Ref: **New River Community and Technical College Hangar Renovation and Addition**

Subj.: **ADDENDUM BULLETIN NO. 2**

New River Community and Technical College Hangar Renovation and Addition

2 FOUNDATION DETAIL, TYP.

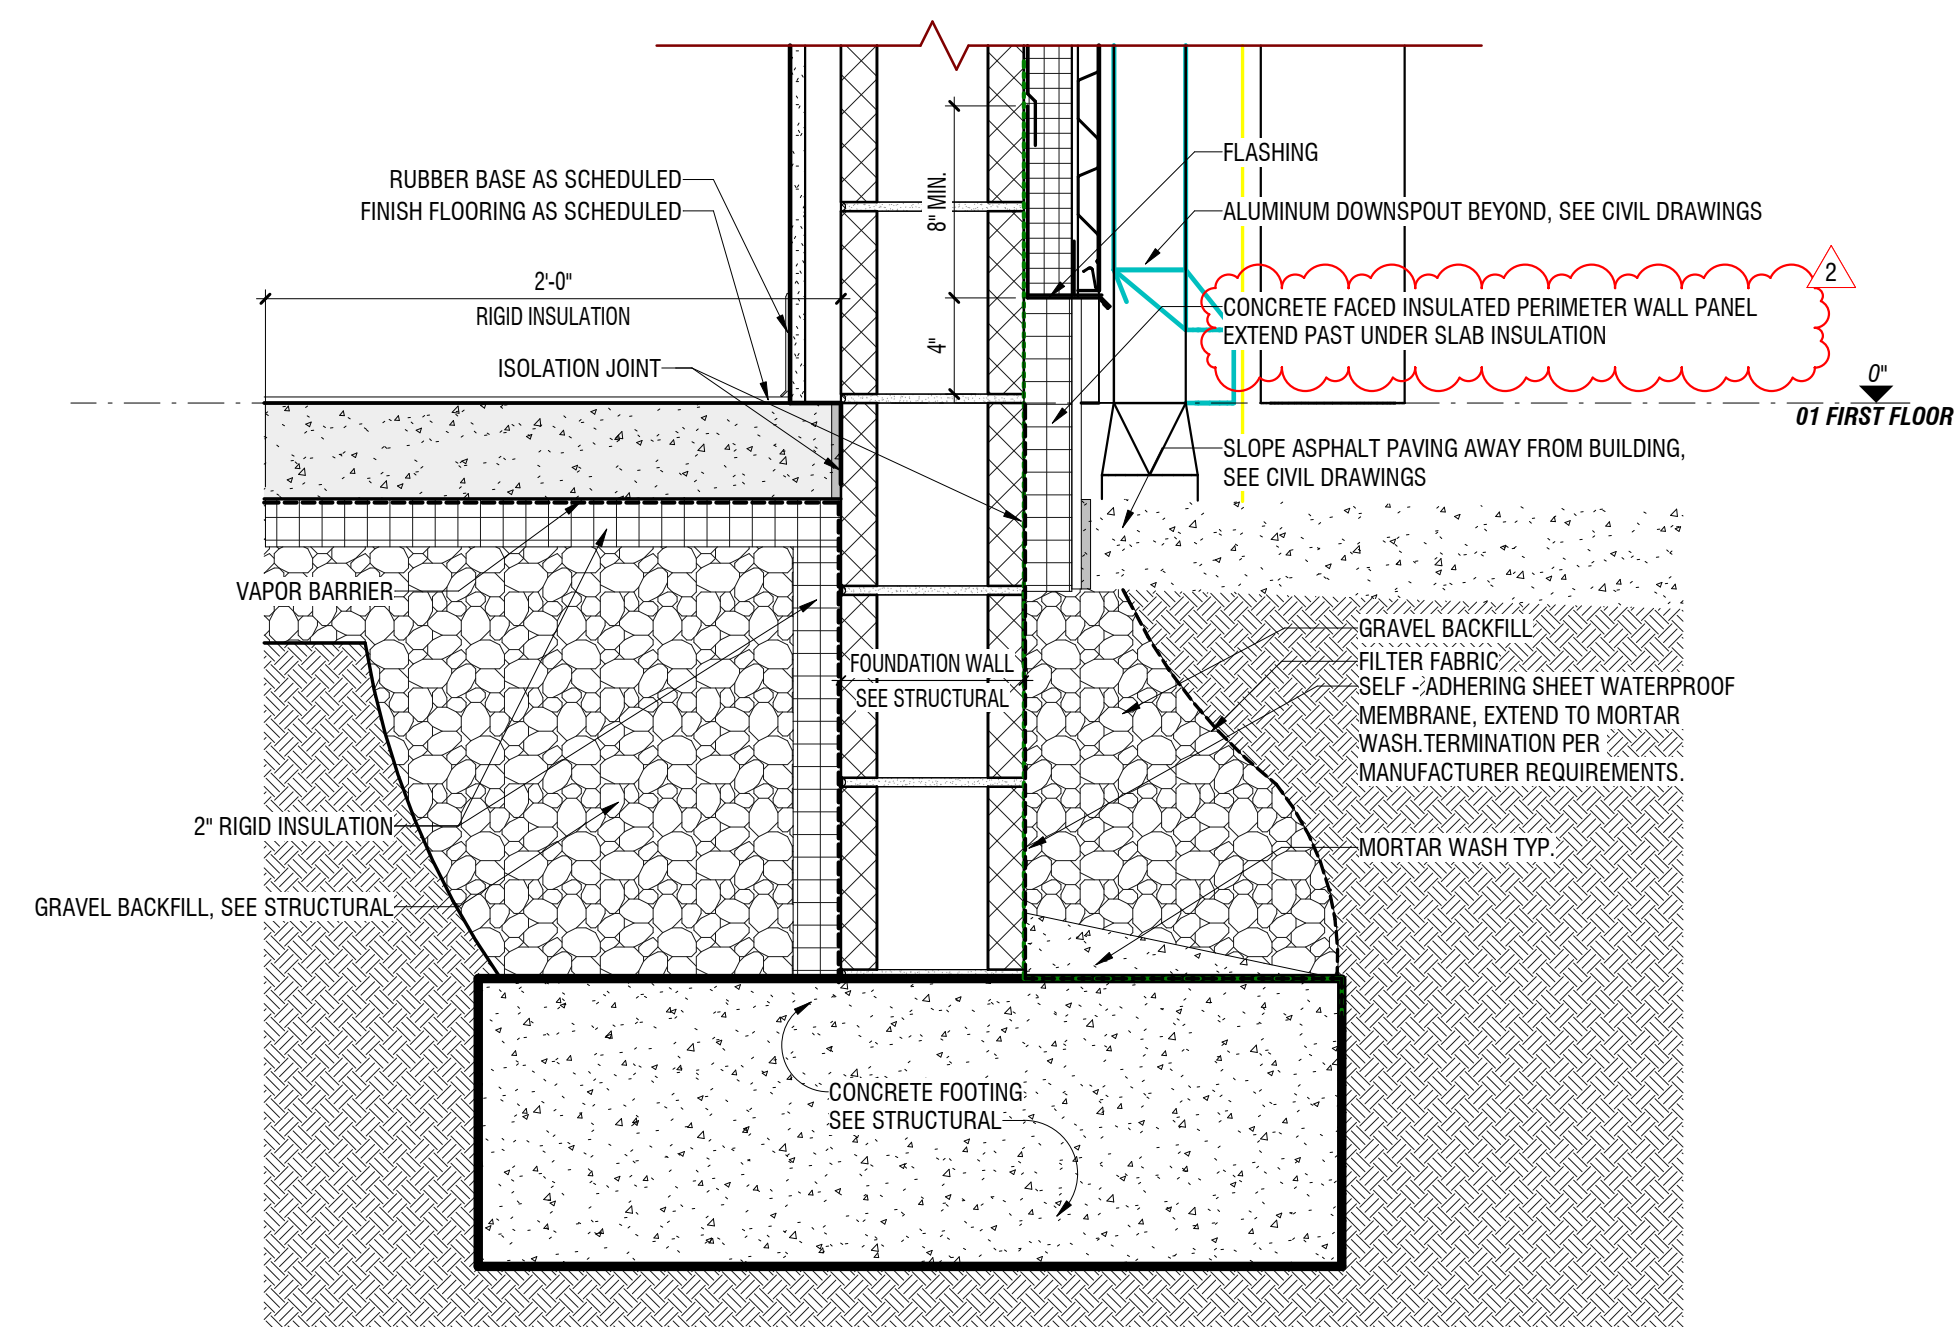
- c. **FOR CLARIFICATION:** Owner furnished equipment to be installed by owner
- d. **FOR CLARIFICATION:** Concrete Faced Insulated Panels can be found on A-3.3 Detail 2. Wall panels to be applied around addition perimeter under Metal Siding and to be extended down past slab insulation.

RFI Auto Number	Question	Response
17	015	Project Manual lists Spec Section 074400 Concrete Faced Panels - these are not shown on building elevations. Please clarify if applicable to project.	See A-3.3 Detail 2 Foundation Detail, TYP. for location of Concrete Faced Insulated Perimeter Wall Panel. Insulated Perimeter Wall Panel to be extended down past slab insulation.
18	014	Referring to Sheet A-2.1/Note #E01 - states painting of existing exterior metal panels. Should base bid include painting bifold door without logo/scheme?	Painting of existing hangar consists of walls, bifold door, and roof is part of the base bid. Logo on roof and bifold door are part of the alternate.
19	013	Referring to Sheet A-1.1 - There is mention of Owner furnished equipment. Please confirm these are also Owner installed.	Yes, owner to install furnished equipment.
20	012	Referring to Addendum #1, Q/A #6 - mentions painting of existing hangar roof entirely. Please confirm this is to be base bid and addendum is just addition of logo.	Painting of existing hangar consists of walls, bifold door, and roof is part of the base bid. Logo on roof and bifold door are part of the alternate.

01 FIRST FLOOR FINISH PLAN
SCALE: 1/8" = 1'-0" SHEET: A-7.1

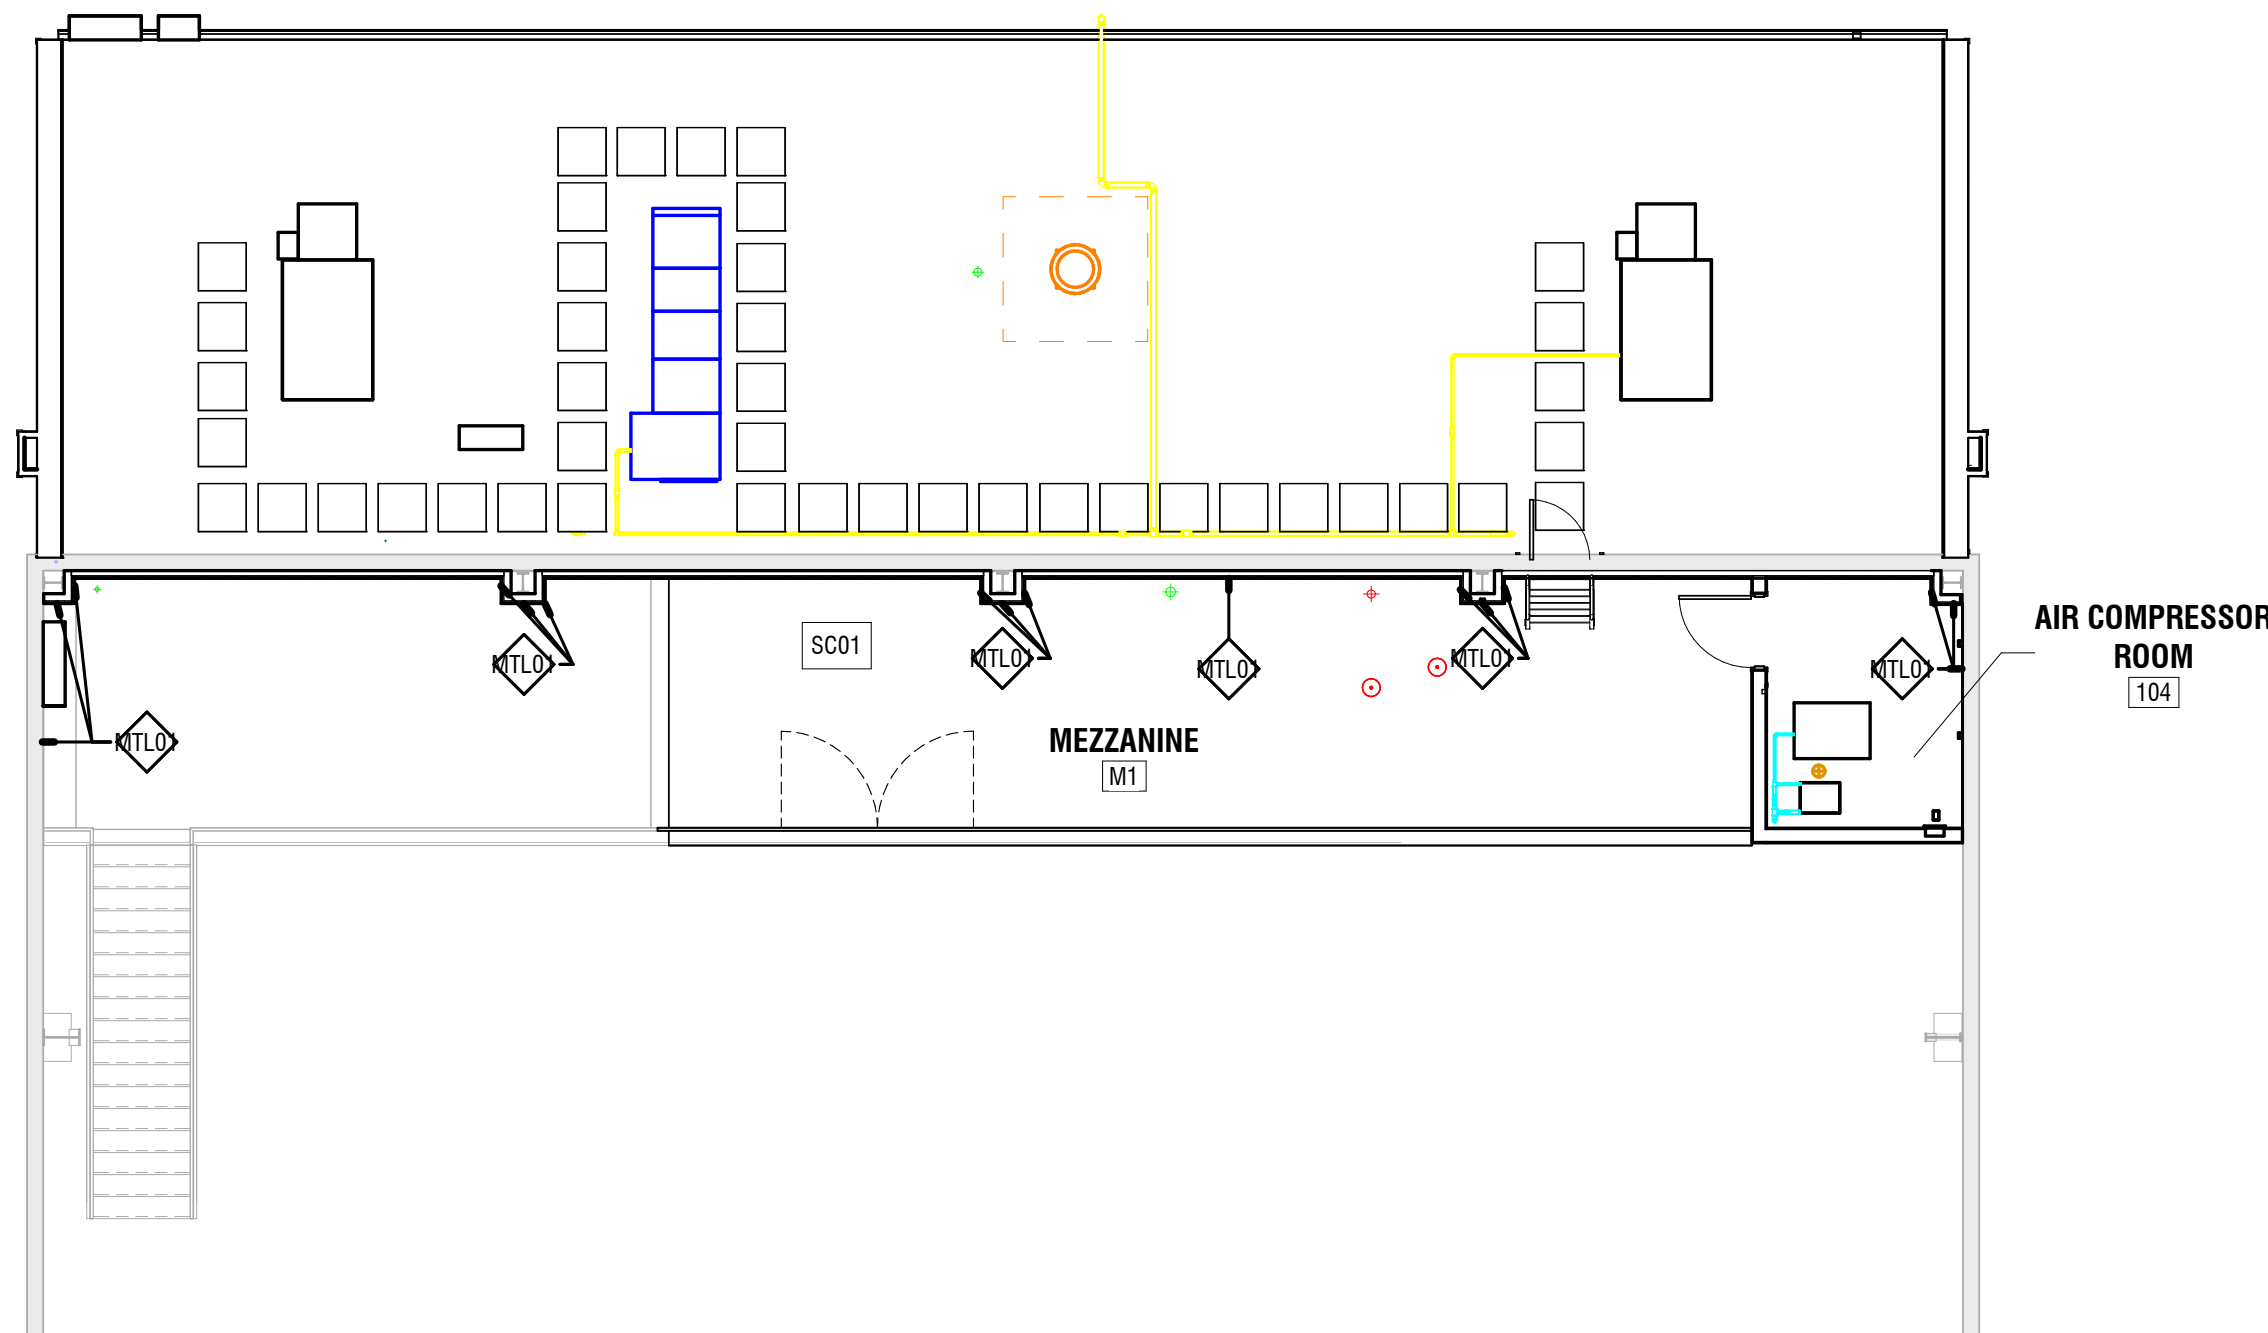
- j. **FOR CLARIFICATION:** Pilasters to be CMU as shown on S100.
- k. **FOR CLARIFICATION:** Resinous integral flooring base is not to be used. Use Rubber base with resinous flooring as scheduled. see Finish Note 5 on Sheet A-7.1 where resinous flooring meets metal panel.

4	028	What type of traffic is the hangar floor going to be seeing? I am being told that the resinous flooring BOD "Resufloor Deco Flake BC" will not handle anything besides foot traffic.	See updated 096723 Resinous Flooring Specification and Sheet A-7.1 in Addendum #2
5	027	Sheet S100 calls for CMU below grade at the 2 pilasters and Sheet A-5.1 shows concrete above grade. Would it be acceptable to just use CMU for the full height of them?	ADS RESPONSE: Use CMU as shown on S100
6	026	Are Details 2/S500, 12/S500, and 13/S500 necessary?	These details no longer apply as they were eliminated during the value engineering process - ADS
7	025	Can you provide a top elevation on the proposed sanitary sewer manhole?	The proposed MH #1 rim elevation should be 2501.8'.
8	024	Please clarify what material is to go over the ceiling framing for Room #104. Interior elevations do not show this wall framing going to deck.	Ceiling Framing for Room 104 to be 6" Metal Ceiling Joist 16" o.c. Walls to go up to underside of joists and gypsum wallboard to wrap from walls over top ceiling joists.

13	019	Referring to Sheet A-7.1 - Interior Materials Legend lists T01 and is tagged in Rooms #110 & 111 but schedule states LVT01. Please clarify what T01 is referring to & which is correct.	Disregard T01 tag. LVT to be used in room 110 and 111.
14	018	Referring to Sheet A-7.1 - Finish Schedule states EXP in Room #102 but RCP on Sheet A-1.1 states ACT. Please clarify.	Office 102 to be ACT.
15	017	Could the existing hangar floor slab thickness be confirmed? Sheet A-3.1 indicates roughly 4" but typically hangar slabs are much thicker.	Existing hangar drawings are not available. The Contractor will field verify the existing foundation size and depth as needed for construction of the new addition. The Contractor will also field verify and match the existing hangar thickness and sub-base for any slab removal and replacement within the hangar.
16	016	Referring to Sheet A-2.1/Note #E13 - references metal grate stairs/landing but is not depicted on drawings. Please clarify if there is to be an exterior set of stairs.	Note E13 no longer apply as they were eliminated during the value engineering process

01 FIRST FLOOR SIGNAGE PLAN

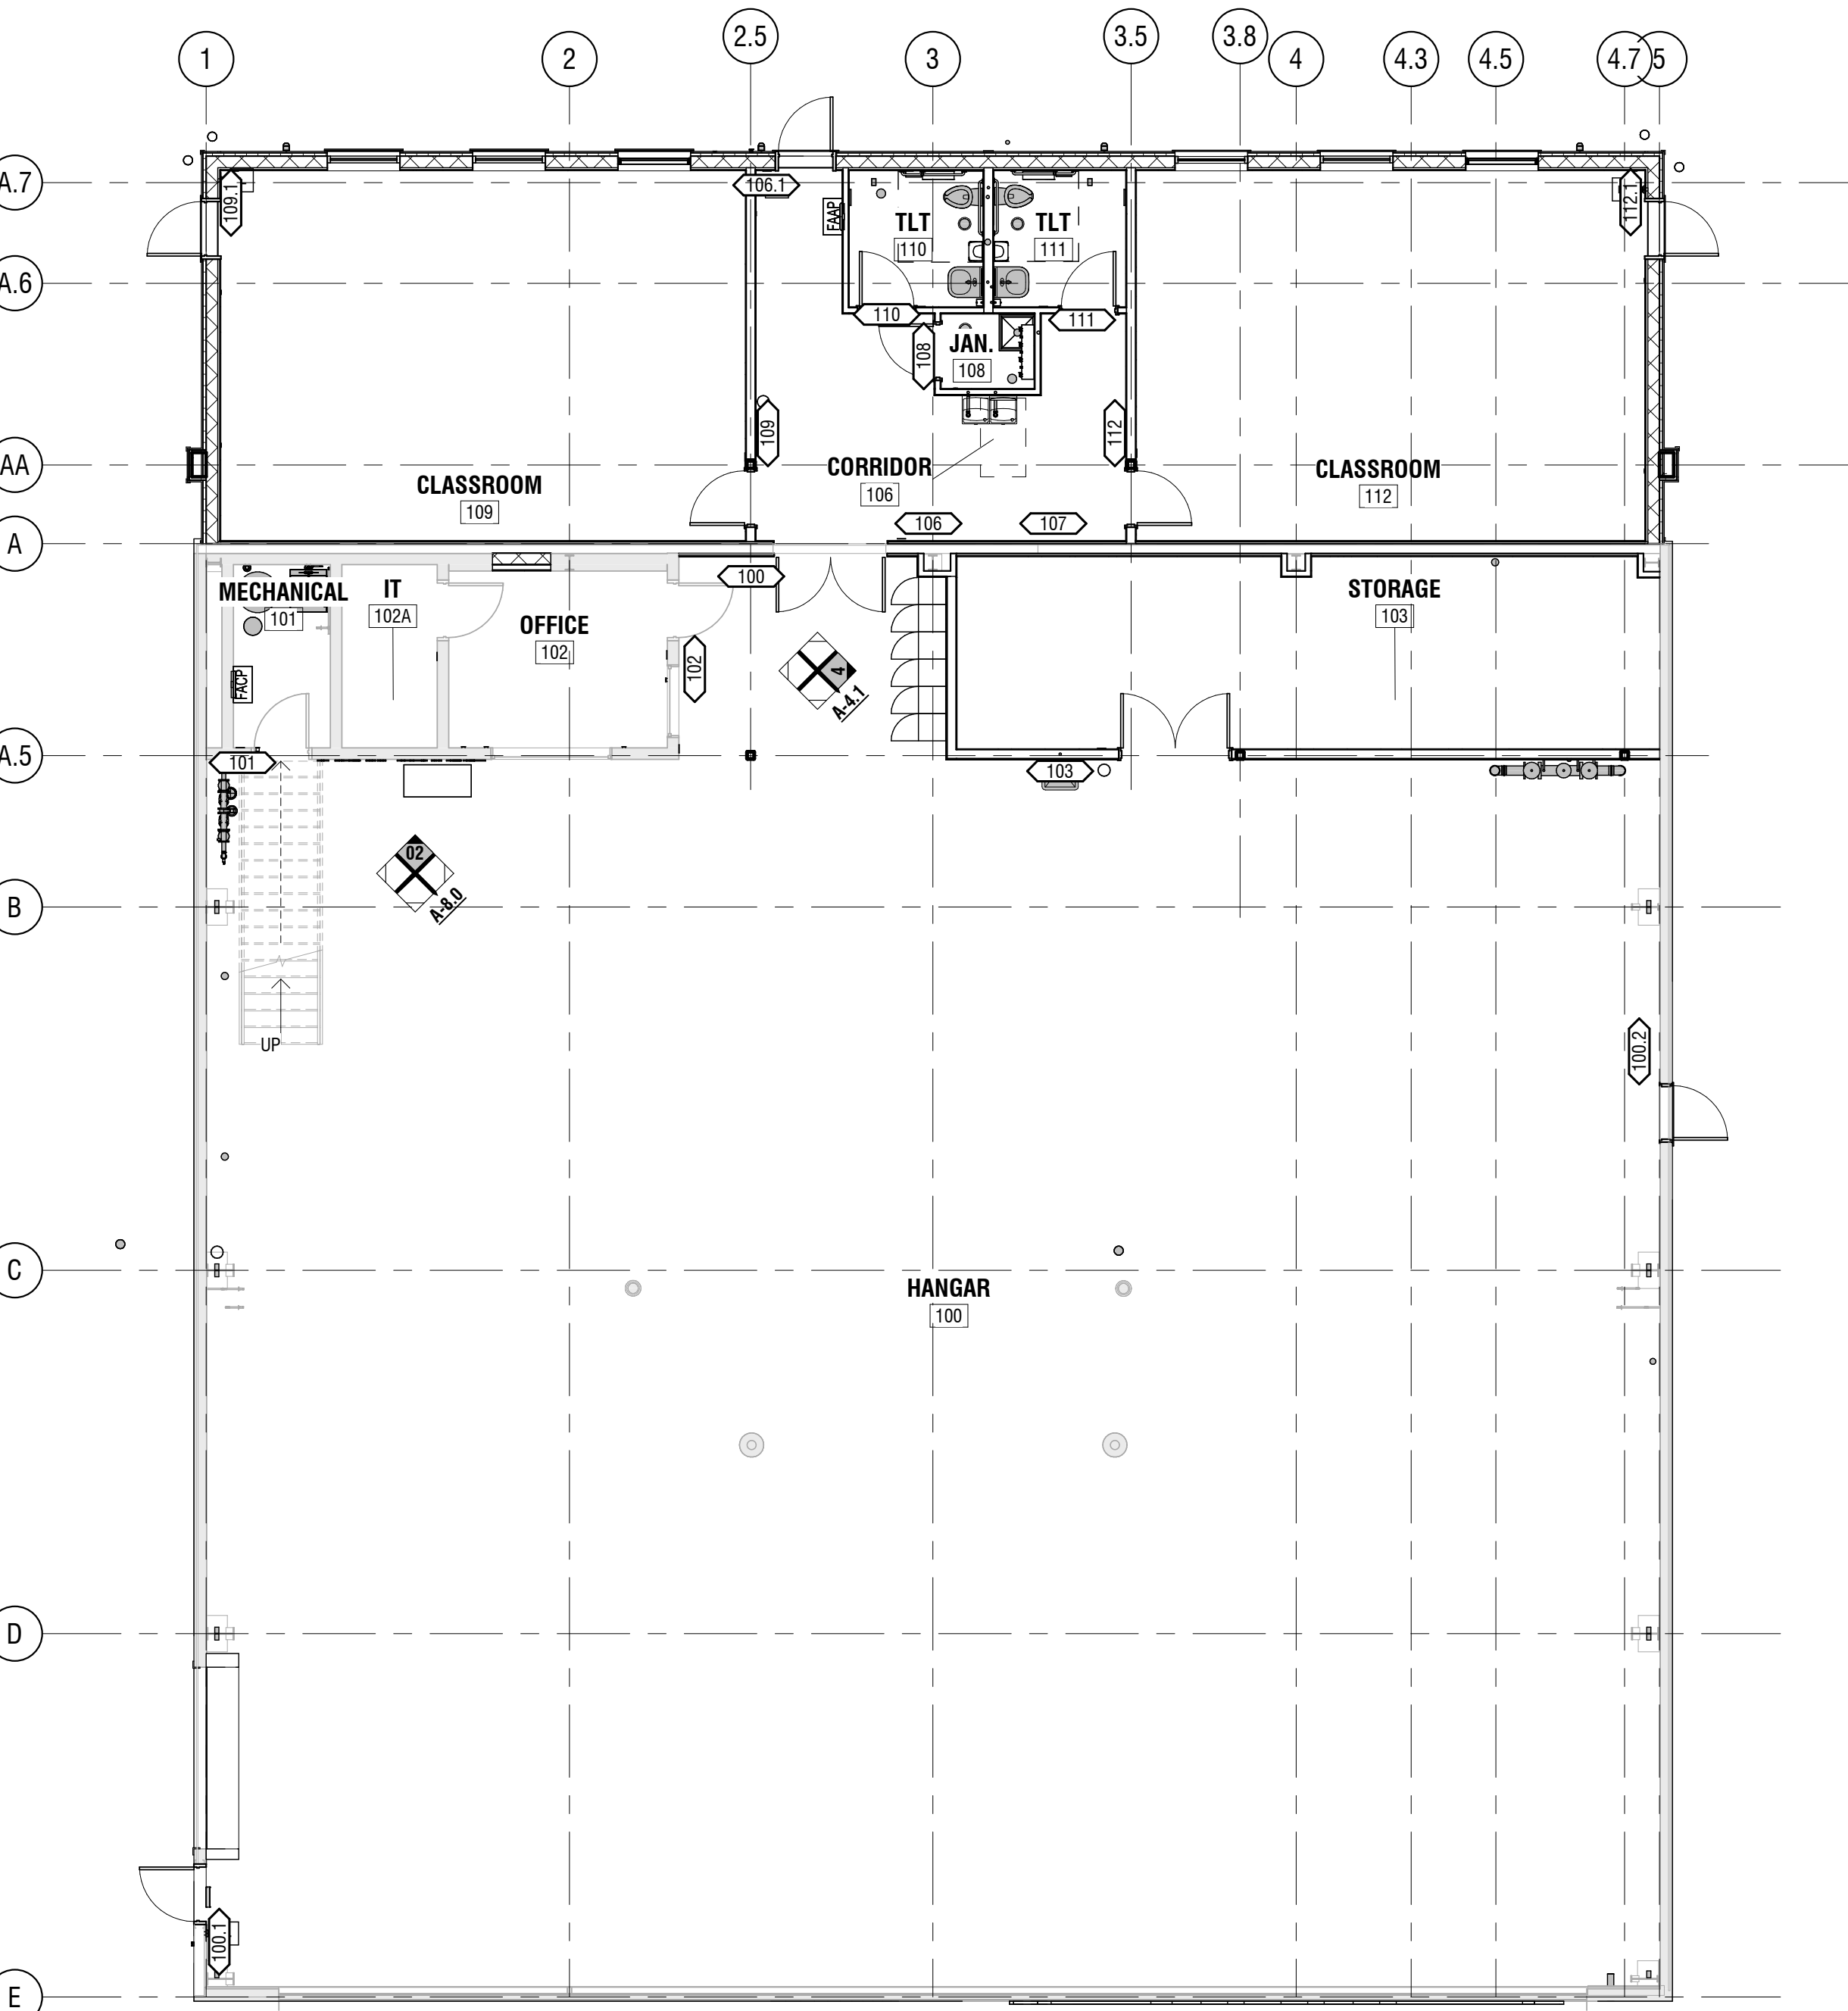
- a. **Drawing G-1.0:** REPLACE sheet in its entirety, see Enclosures. Updates have been clouded and tagged.
- b. **Drawing A-3.3:** REPLACE sheet in its entirety, see Enclosures. Updates have been clouded and tagged. Updated note for Concrete Faced insulated perimeter wall panel.
- c. **Drawing A-6.0:** REPLACE sheet in its entirety, see Enclosures. Updates have been clouded and tagged. Updated Sill and Jamb details for Overhead Coiling Door.
- d. **Drawing A-7.1:** REPLACE sheet in its entirety, see Enclosures. Updates have been clouded and tagged. Revised Finish Schedule and tag removal of T01.
- e. **Drawing A-8.0:** REPLACE sheet in its entirety, see Enclosures. Updates have been clouded and tagged. Add signage to Room 104 and remove Type V01 signage.

9	023	Project Manual lists Spec Section 088300 Mirrors. Please confirm if this spec is applicable to the project as Spec Section 102800 Toilet Accessories already lists 'MR' mirrors that is shown on Sheet A-4.1.	Yes, spec section 088300 Mirrors is applicable for project. Spec section 102800 2.2 G2 to be Frameless Mirror as specified in 088300
10	022	Project Manual lists Spec Section 084313 Aluminum-Framed Storefronts but drawings only show Aluminum Windows. Please confirm if this spec is applicable to the project.	Delete Spec section 084313 Aluminum-Framed Storefronts from the Table of Contents
11	021	Referring to Sheet A-8.0 - Plan does not show mezzanine level. Please confirm signage is not needed at Room #104.	Type R03 signage to be added beside door for Room 104 Air Compressor Room.
12	020	Referring to Sheet A-8.0 - Could the location(s) of Sign Type V01 be clarified?	Remove Type V01, not used in project.
